**FINAL DESIGN REVIEW
DATA PACKAGE
BEAM TUBE MODULE
DESIGN & QUALIFICATION TEST
CONTRACT C146**

**CDRL #15
DRD #9 ITEM II**

VIEWGRAPHS & ASSESSMENT

**CBI TECHNICAL SERVICES COMPANY
PLAINFIELD, ILLINOIS
APRIL 11, 1994**

BEAM TUBE / EXPANSION JOINT CONFIGURATION (392 REQUIRED)

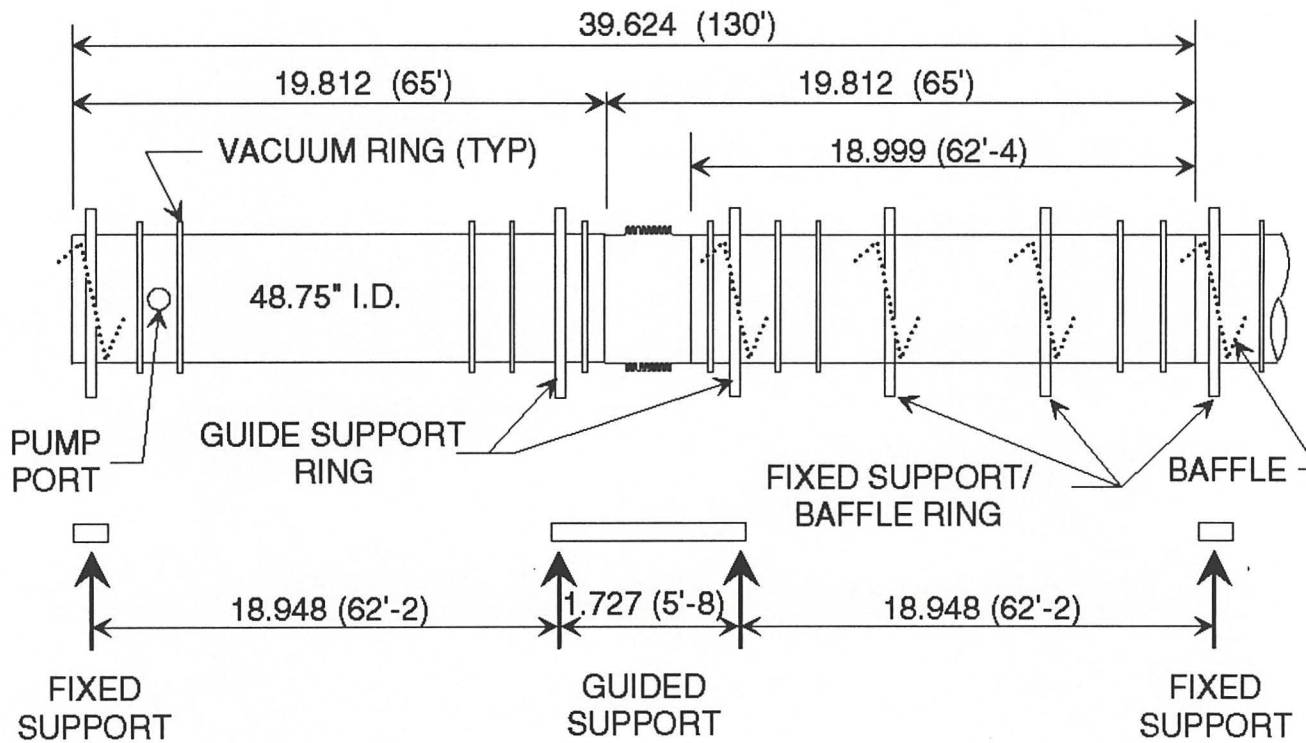
Need know sigl #
weight of the beam +
tube stuffing in

TUBE LENGTH VS RELATIVE COST

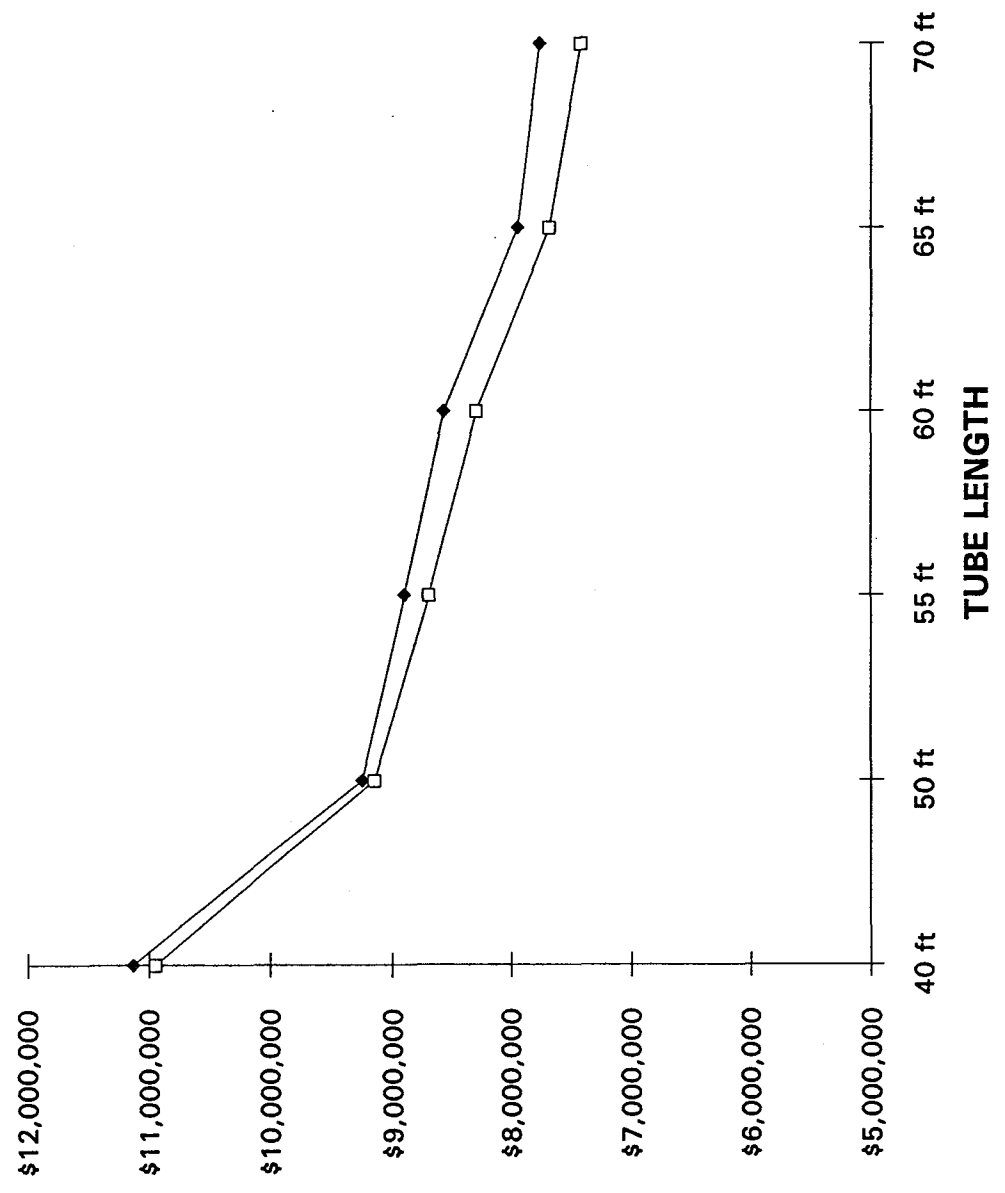
~~FFD~~
if there is no
cost of length
but as a risk
reducing this is
OK

BEAM TUBE SUPPORTS

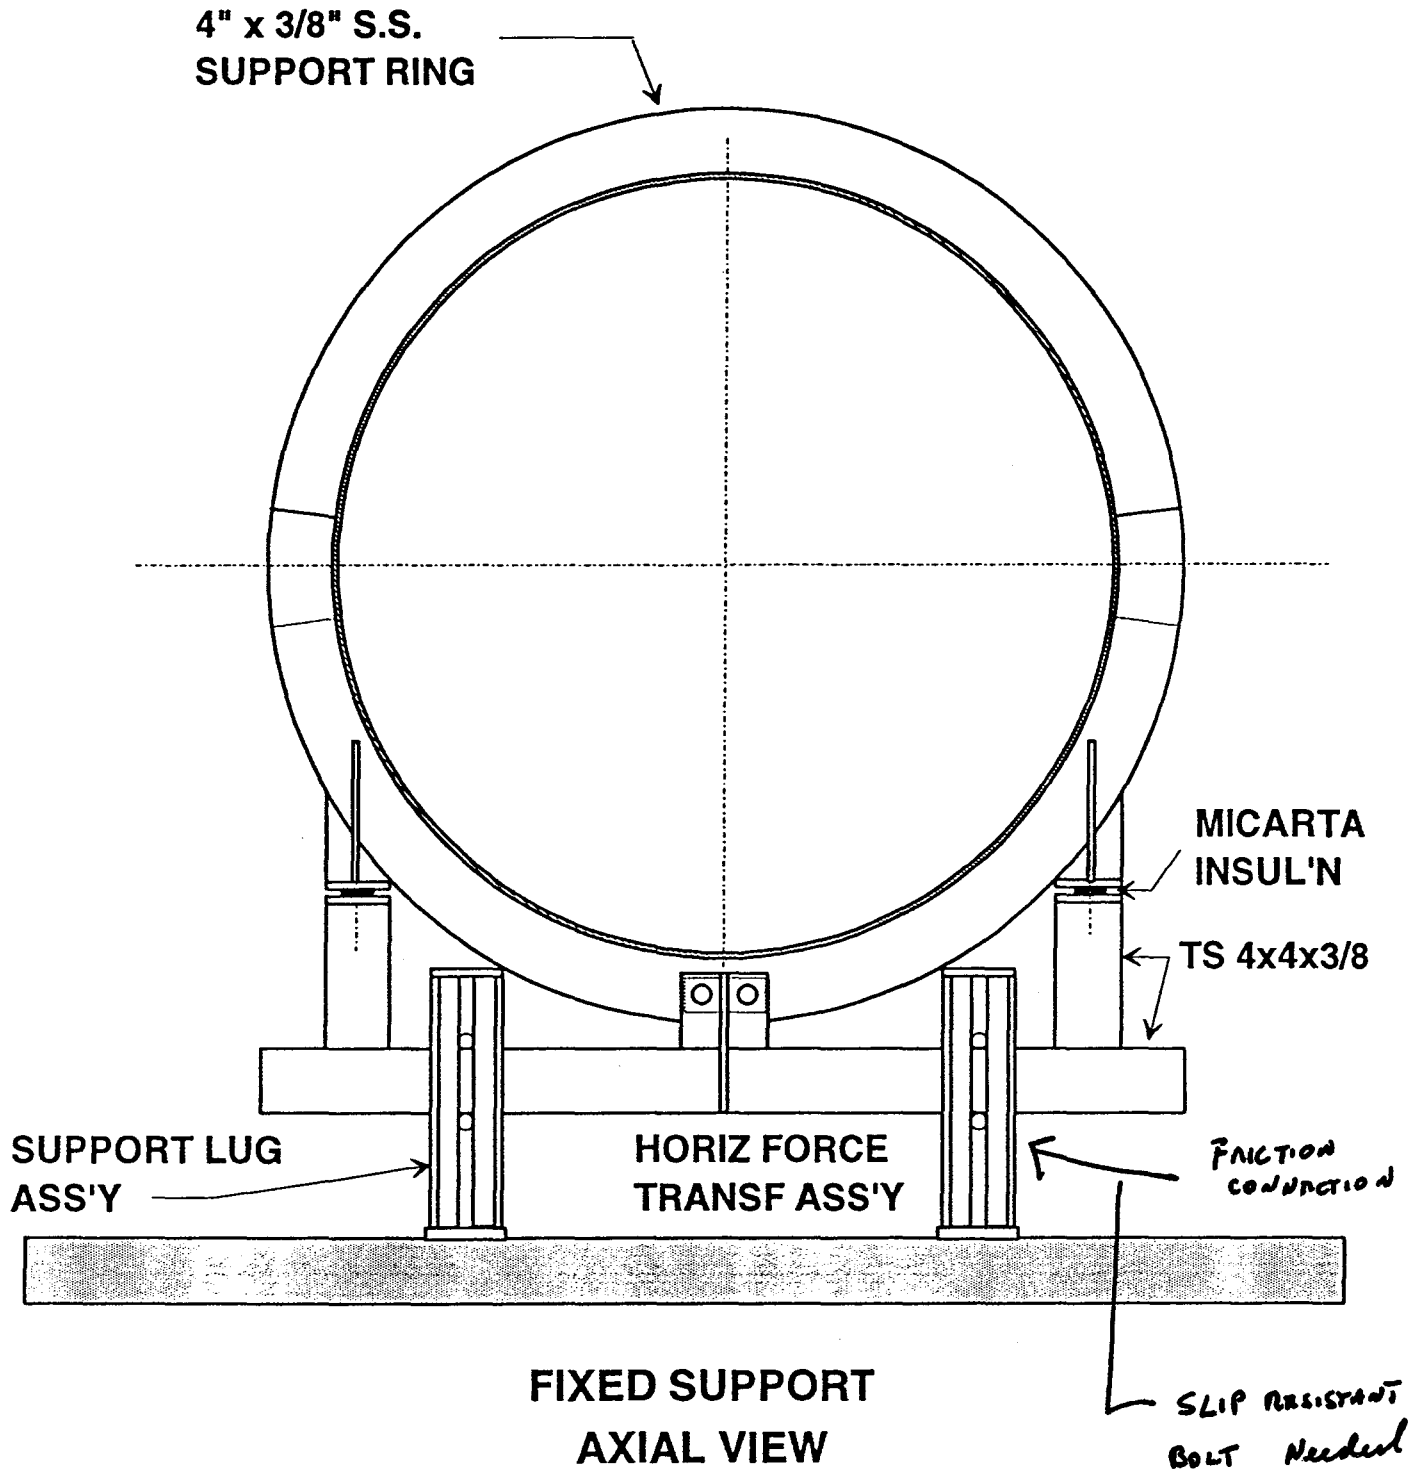
*Better to say
what were
the criteria
and how the
const.
designs
retrofit
them*

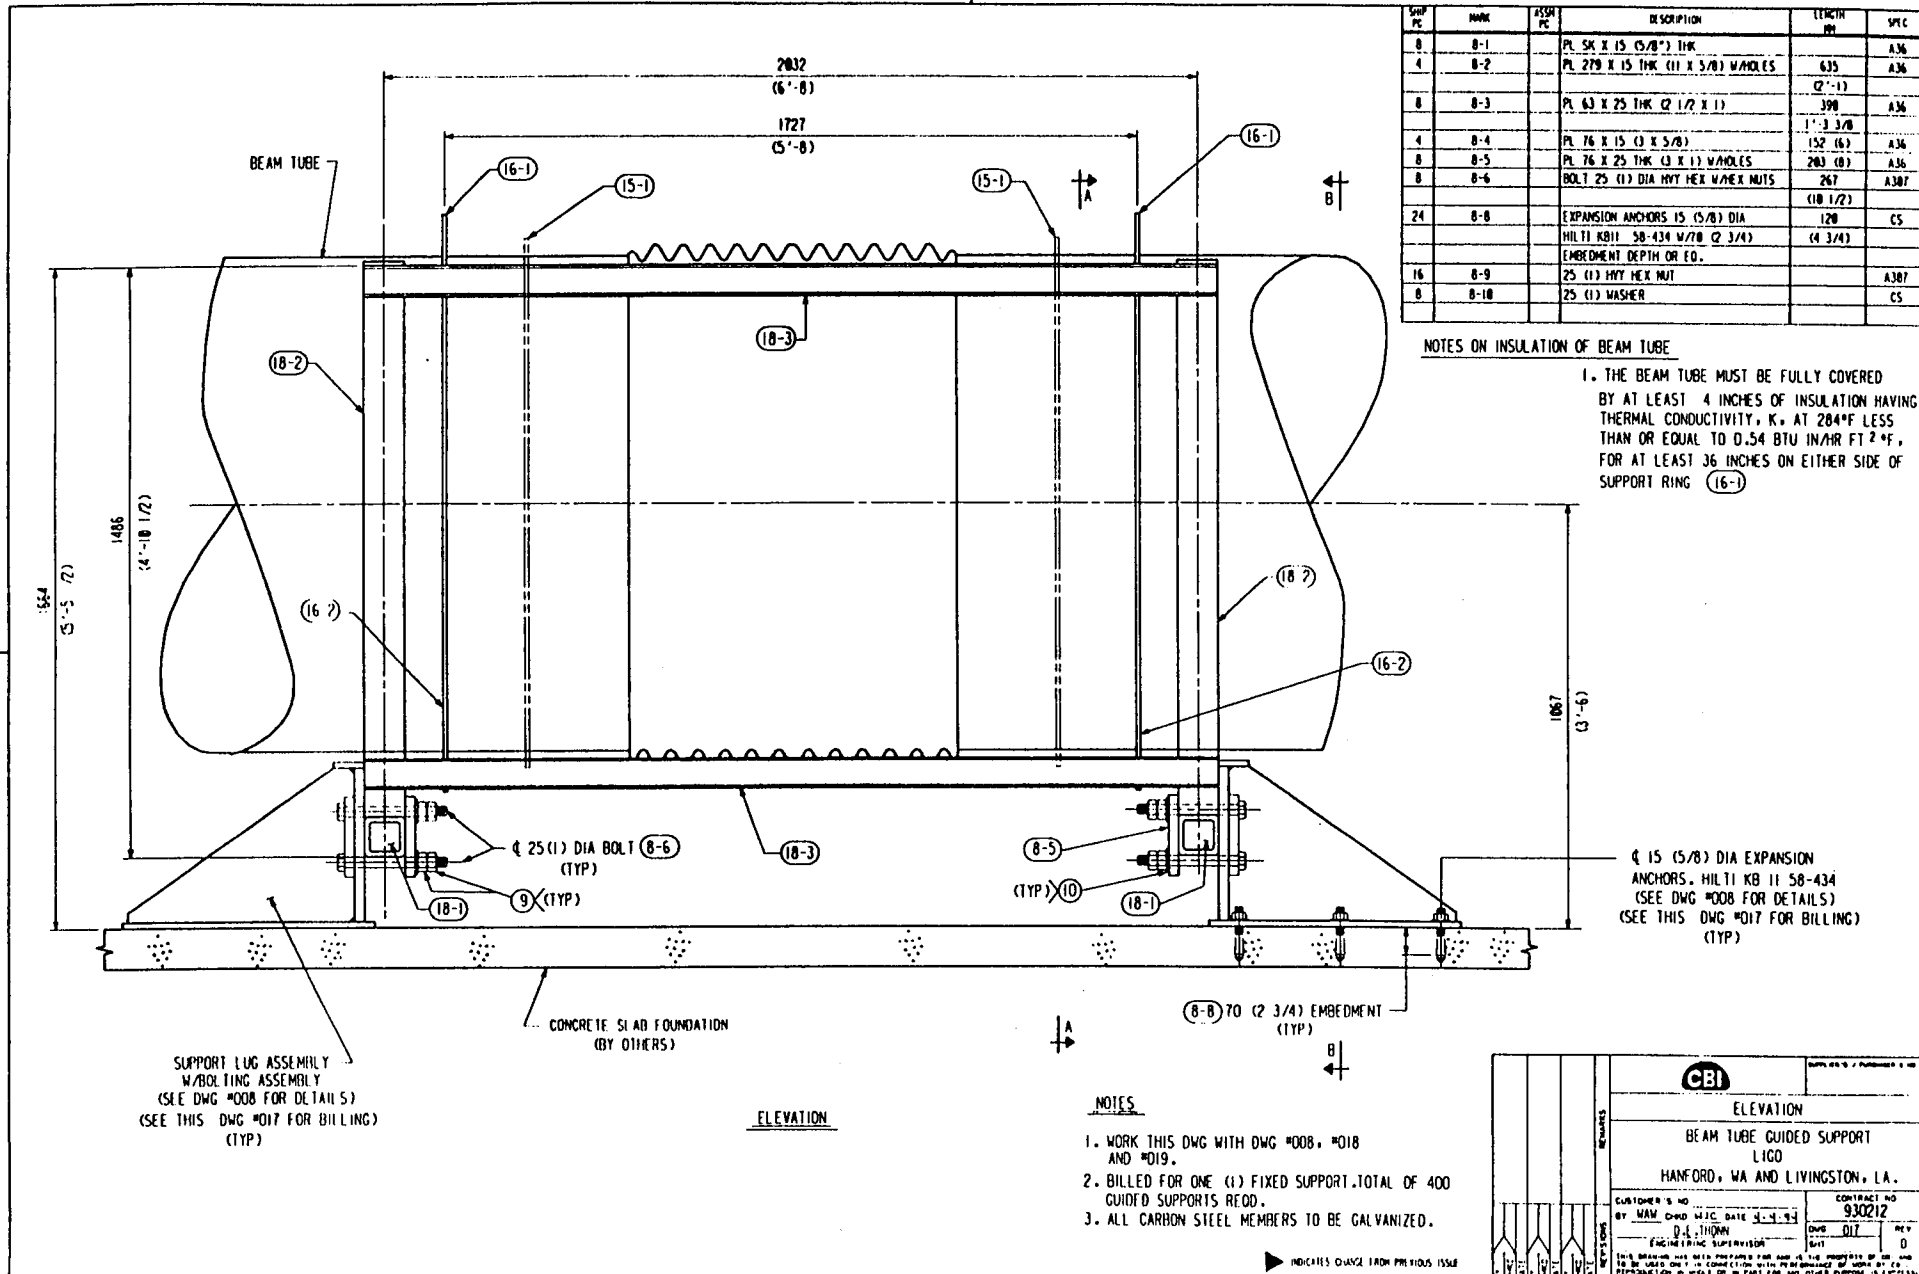
Need Schedule
To show where
is the confusion

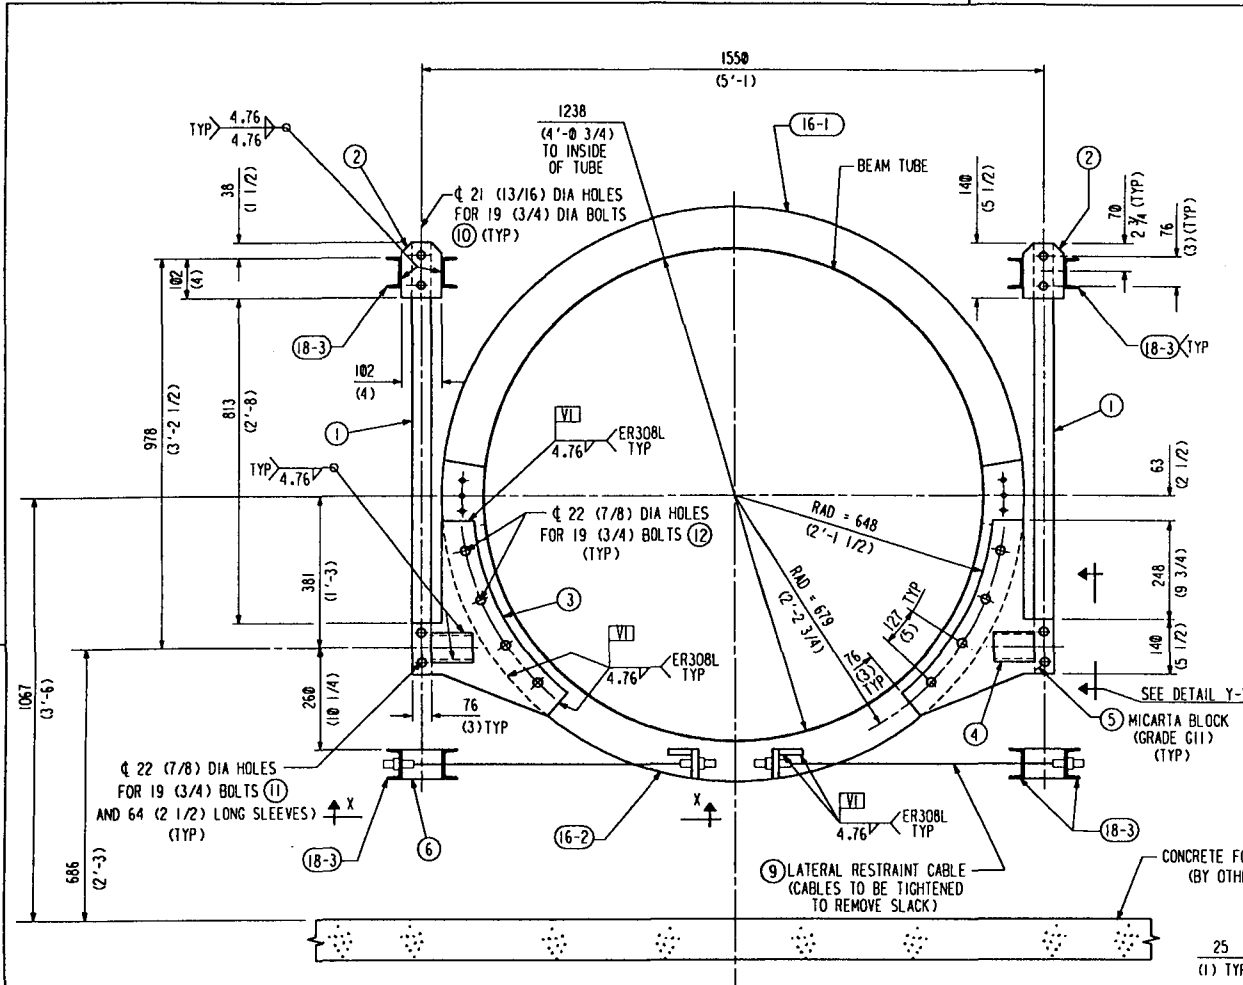
How is this to be conveyed to the vendor

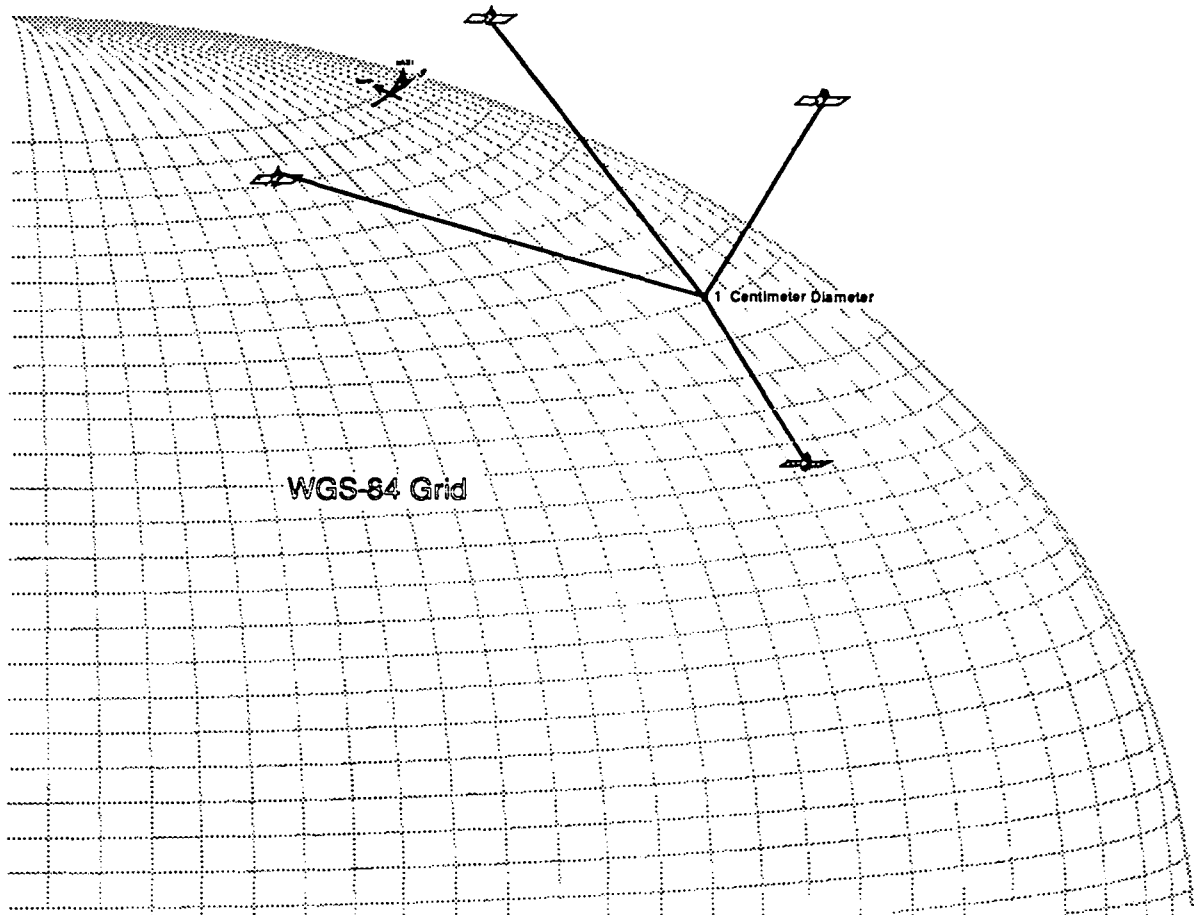
*Relative
align of
a site
is critical
Calculate
align of
points
between
sites
set a
range
current*
